**DEVELOPMENT ASSESSMENT REPORT – DA143/20
DEMOLITION OF EXISTING STRUCTURES AND CONSTRUCTION
OF A MIXED-USE DEVELOPMENT COMPRISING A 6 LEVEL
RESIDENTIAL FLAT BUILDING, GROUND FLOOR COMMERCIAL
PREMISES AND BASEMENT CARPARKING
115 Martini Parade, Lithgow (Lots 608-611 DP 9370)**

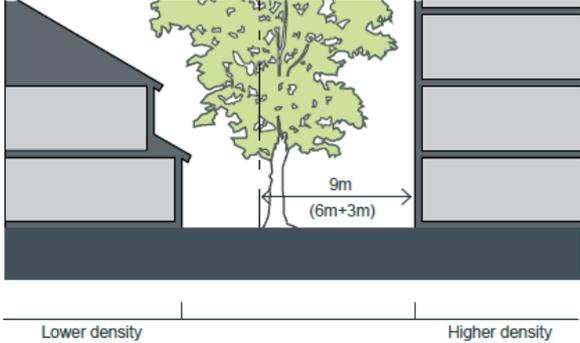
Objective 3E-1 Deep soil zones provide areas on the site that allow for and support healthy plant and tree growth. They improve residential amenity and promote management of water and air quality	The ADG encourages the incorporation of deep soil zones as indicated in the objective. In the context of the subject site, this is considered a critical element that has not been incorporated into the design. Deep soil zones and the inclusion of landscaping and tree planting on the site would assist in achieving a better integration of the development with adjoining land uses. Given the above, the absence of deep soil zones in the design is not supported. It is considered that the development application has inadequately justified why the design criteria and design guidance provided in the ADG under this objective should not be met.
Objective 3F-1 Adequate building separation distances are shared equitably between neighbouring sites, to achieve reasonable levels of external and internal visual privacy	The ADG provides direction on acceptable building separation in circumstances where medium/high density development adjoins low density areas such as in the circumstance of the subject site. The development application has not adequately addressed this and has not justified why a greater separation of the building from the side boundary has not been provided. The ADG recommends a building setback of 9 metres in circumstances where the adjoining

ADG Provisions	Comments
	<p>land contains lower density development (see image below). It is considered that if the design included a greater boundary setback from the southern boundary, some of the overshadowing and bulk/scale issues of the development could be mitigated.</p>  <p>The proposed development will result in a solid masonry wall with no setback along most of the boundary with 113 Martini Parade. This wall will be up to 6 metres in height and will represent a significant monolithic bulk against the boundary of 113 Martini Parade. In addition, above the ground level, Levels 1, 2 and 3 of the building have a minimal setback of 3.5 metres from the property boundary. The proposed setbacks are not consistent with the direction and guidance provided in the ADG and represent a significant unreasonable negative impact on the amenity of the adjoining dwelling at 113 Martini Parade.</p>
